# Attachment G

**RE: Robert Ching Property, Biological Resource Analysis for Well Site**  
**APN 241-191-005**  
**161-B Sprindrift Road, Carmel Highlands, CA**

Project: 161-B Spindrift/Proposed Well Site

Location of  
Stake  
←

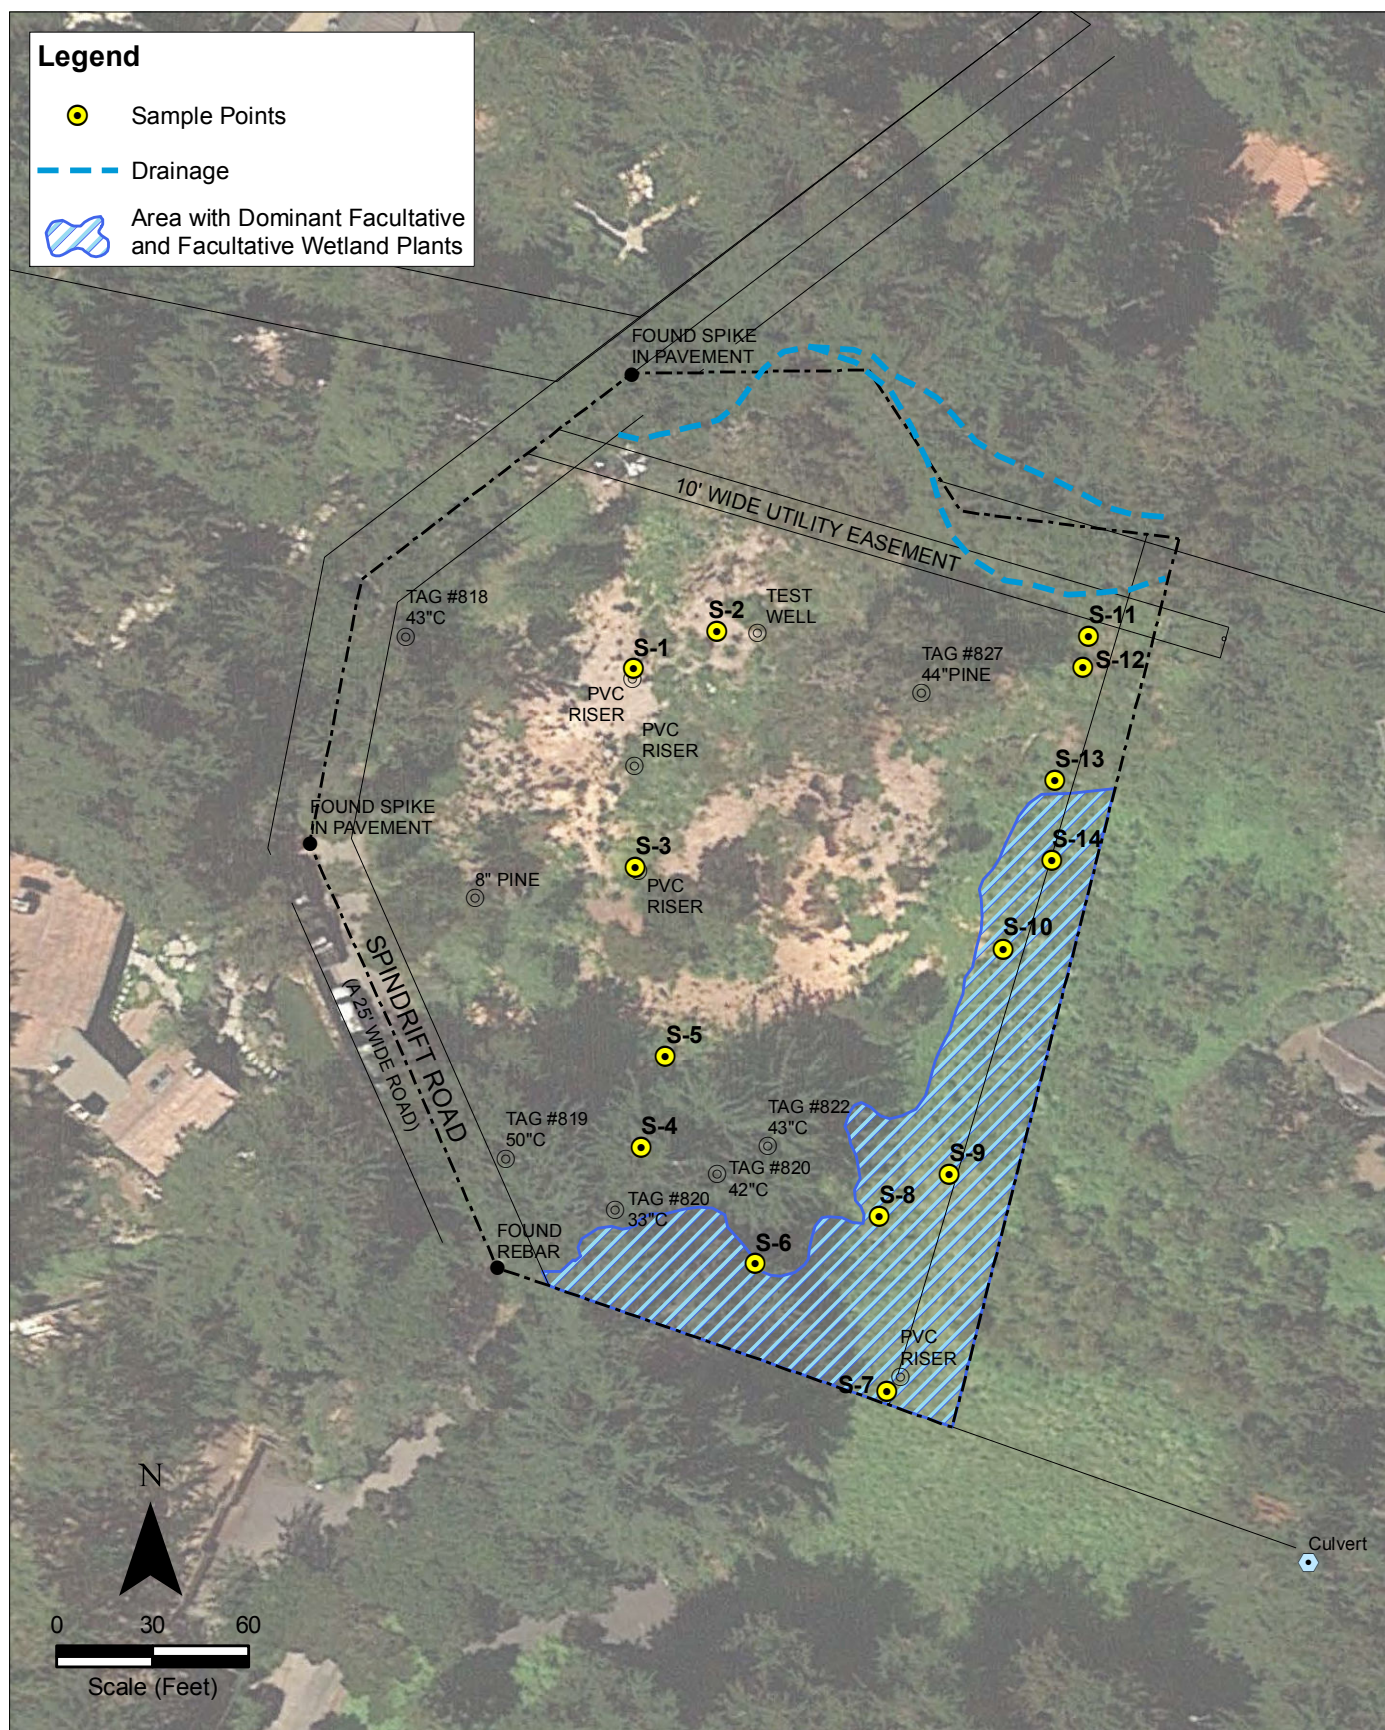
A single lath type stake was observed adjacent to the trees. It can be assumed that it indicates the location of the proposed well (at arrow).

From offsite, it appears to be approximately 10 feet from the base of one tree and 30 feet from the other.

The potential impacts based on the location of the stake include:

- Damage or removal of structural roots that could destabilize the trees
- Removal of absorbing roots needed to provide moisture and nutrients to the tree
- Suffocation of absorbing roots by the by soil and rock by-products that would cover the root zones.
- Modifications to natural soil moisture or oxygen absorption.
- Damage to remaining tree canopy by large equipment

Ideally, the well site proposed for this property should be relocated outside the Critical Root Zone of all protected trees.
